# Little Crow

*Little Crow Solar Park, Scunthorpe*

## APPLICANT'S RESPONSE TO EXAMINING AUTHORITY QUESTIONS EXQ3

### DEADLINE 6

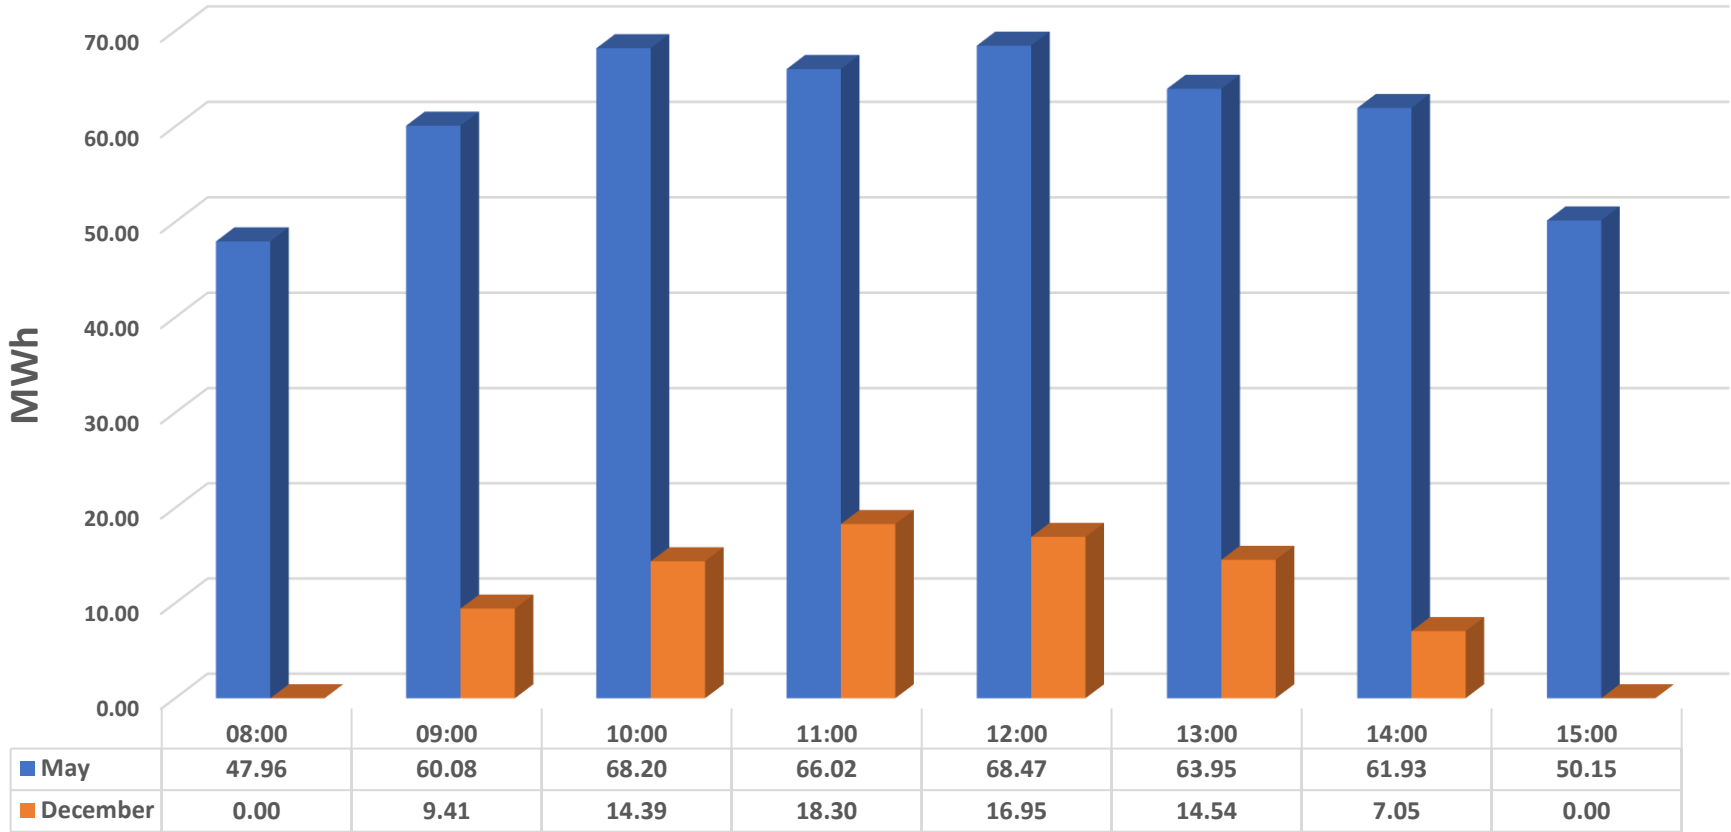
<b>6. Draft Development Consent Order (DCO)</b>			
3.6.1	The Applicant	<p>With respect to the generating capacity for the Proposed Development the ExA notes the Applicant's response to second written question 2.6.5 [REP4-018], most particularly the Applicant's view '... that it is not possible to specify a maximum capacity ...' in any made DCO and that if a generating capacity was to be set the Applicant considers this should '... relate to the combined capacity of both the solar and battery ...' and be a '... combined capacity of 500MW as this would allow some flexibility for reasonably foreseeable technological advances'.</p> <p>If a maximum generating capacity was to be stated in any made DCO, could that reasonably be set at 500 megawatts (MW) as a combined capacity for the solar array and the battery electrical storage system (BESS), given that: 500 MW would significantly exceed the candidate designs of 150 to 200 MW peak for the solar array and 90 MW for the BESS used for the purposes of undertaking the environmental impact assessment for the Proposed Development (as reported in the submitted Environmental Statement); and the available grid connection limit of 99.9 MW?</p>	<p>As previously confirmed, the generating capacity of the solar array and the battery energy storage system (BESS) are not parameters upon which the development has been assessed in the environmental statement (ES), and therefore any restriction on maximum capacity imposed via the DCO would be purely arbitrary. The ES refers to a candidate design in order that the physical parameters of the development (i.e. the panels and the battery) could be assessed. That candidate design was based on an example capacity that could be accommodated within the size of panels and battery assessed at the time of the preparation of the ES and the DCO Application. As has been demonstrated by the Applicant during the Examination, at ISH and in the Technical Guide [ref], technology for solar development is advancing all the time and there is no reason why a greater capacity couldn't be accommodated within the physical parameters of the ES, thereby having no greater environmental impact than set out in the ES. The Applicant's response to ExQ2.6.5 (Document Reference 9.33 LC OTH, PINS Reference REP4-018), whilst noting the Applicant's firmly held view that no maximum should be imposed, proposed 500MW combined capacity, should the ExA be inclined to suggest that a maximum should be imposed, in order that such technological advances could be embraced within the parameters of the ES.</p> <p>The Applicant explained in ISH2 that 535Wp panels (a feasible and currently available option within the design parameters) would produce around 200MW generation and need at least a 90MW battery, possibly more to allow effective management of the project within the constraints of the available grid capacity.</p> <p>It is therefore evident that the combined capacity of the solar array and the BESS based on the currently available technology, will exceed 300MW.</p>

ExQ3	Question to:	Question:	Applicant response
			<p>The Applicant also explained at ISH2 that it is likely that c600Wp panels would be available by the earliest date at which the development is likely to commence, but the Applicant is also conscious that the proposed time limit for commencement of the authorised development referred to in requirement 2 at Schedule 2 Part 1 of the dCO (Document Reference 3.1F LC DCO Revision F submitted at Deadline 6) is five years from the date that the Order comes into force. Assuming that the Order would come into force in April 2022 (the estimated decision date) then the Applicant considers that it is appropriate to contemplate technological advances within that time frame. Experience of solar panel development to date strongly indicates that panels of a greater capacity but within the physical parameters of those currently available, are likely to come onto the market within that period.</p> <p>If technology advances allowed for greater capacity panels (within the ES parameters), then similarly a greater BESS would be required in order to allow the efficient operation of the project given the grid capacity. As for panel development, battery technology is advancing at pace meaning that more efficient batteries are likely to be available within the physical parameters of the BESS assessed in the ES to compliment any advances in panel development.</p> <p>The Applicant's suggestion of a 500MW capacity limit is itself entirely arbitrary but represents its estimation of a reasonable capacity based that is unlikely to be exceeded based on the above principles, notwithstanding the Applicant's clearly stated position that no limit should be imposed.</p> <p>With regard to the available grid connection, the current limit of 99.9MW is fixed at a point in time and it may be possible to increase this in the future, however, even if it remained at that limit for the lifetime of the development, the BESS would enable the project to be managed effectively within that limit. (as explained in [the Applicant's response to ExQ2.1.2 (Document Reference 9.33 LC OTH, Pins Reference REP4-018) and the Technical Guide (Document Reference 9.20A LC OTH REVISION A, PINS REFERENCE REP4-014).</p>

**APPENDIX 1      HOURLY COMPARISON GRAPHS**

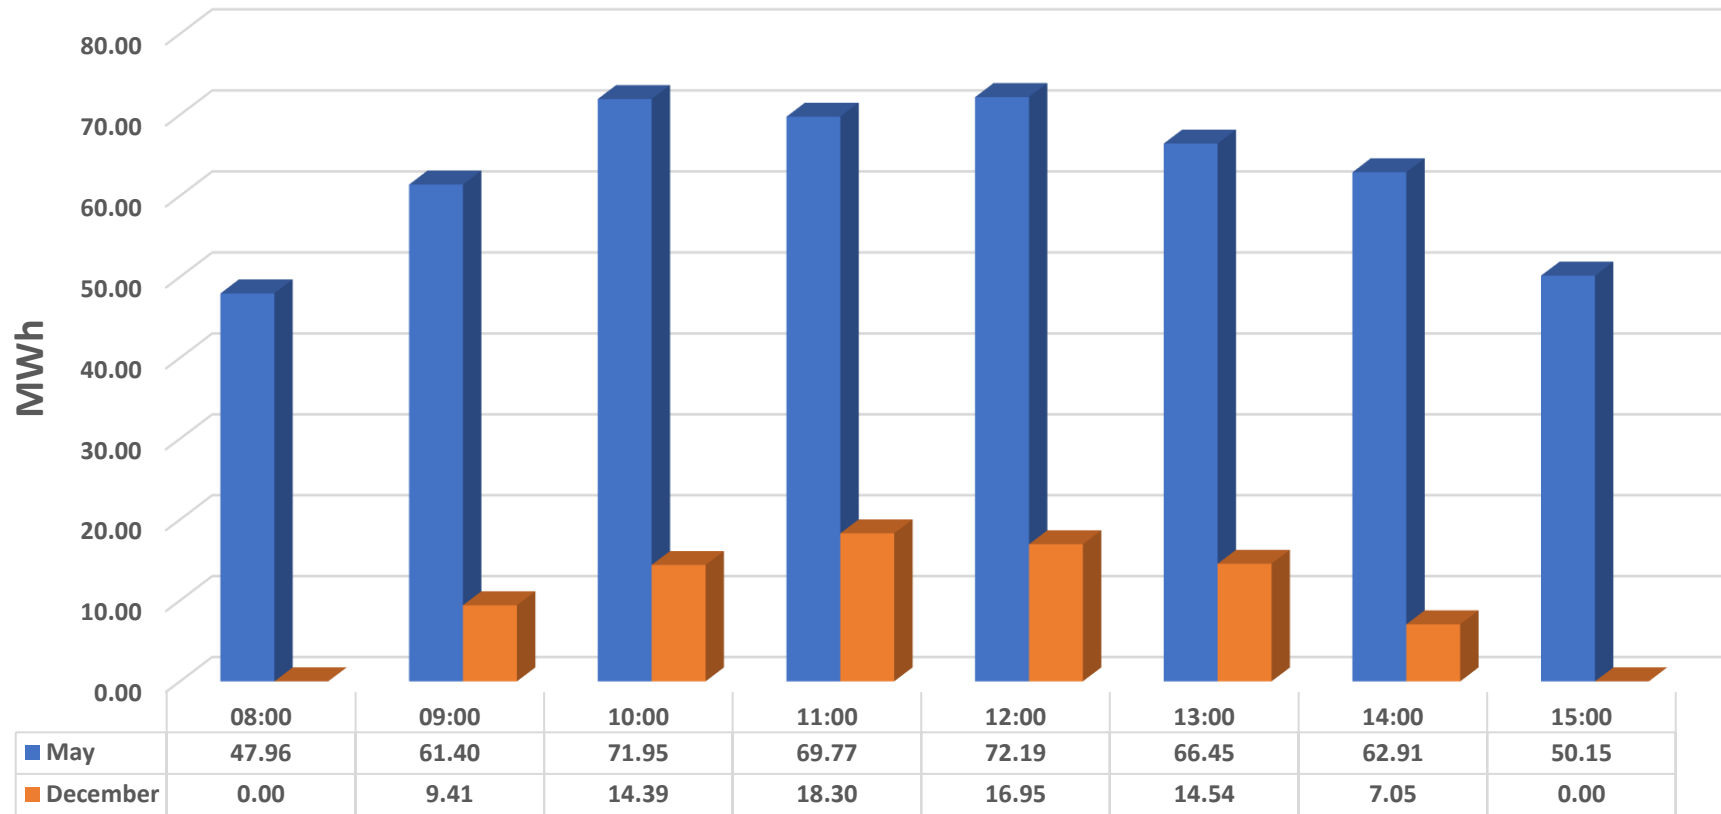
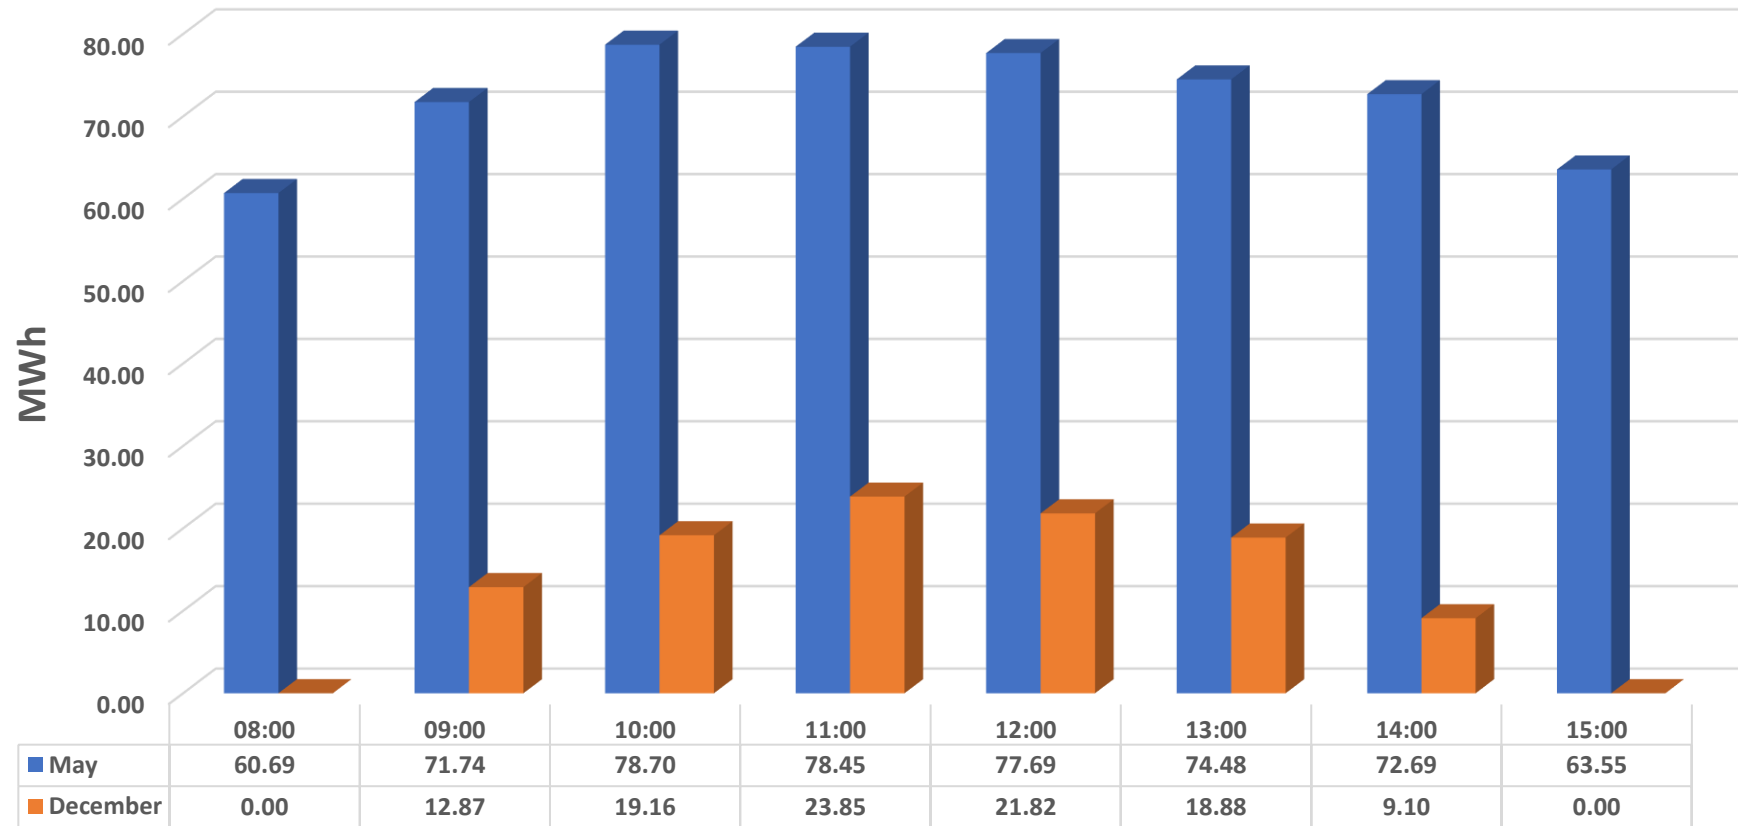
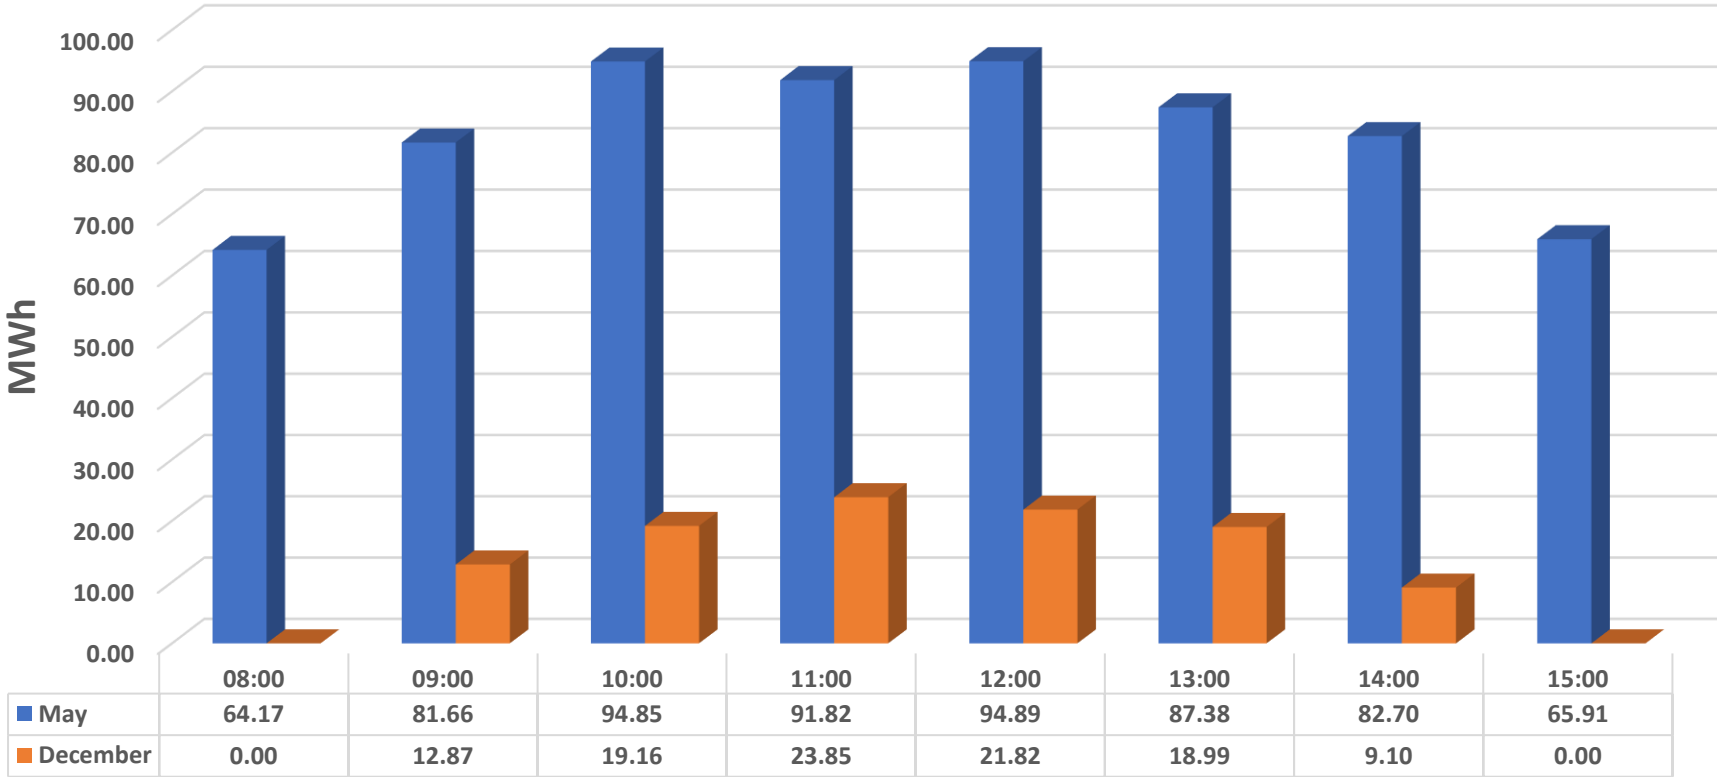
3.1.2	The Applicant	Further to the submission of the projected hourly electricity output in a calendar year for the candidate design for the Proposed Development [REP4-019], please show on a graph or graphs the average hourly predictions for megawatt hour exportation to the grid for the months of May and December.	The Applicant encloses at Appendix 1 the graph requested for REP4-019, as well as graphs for REP4-020, REP4-021, REP4-022.
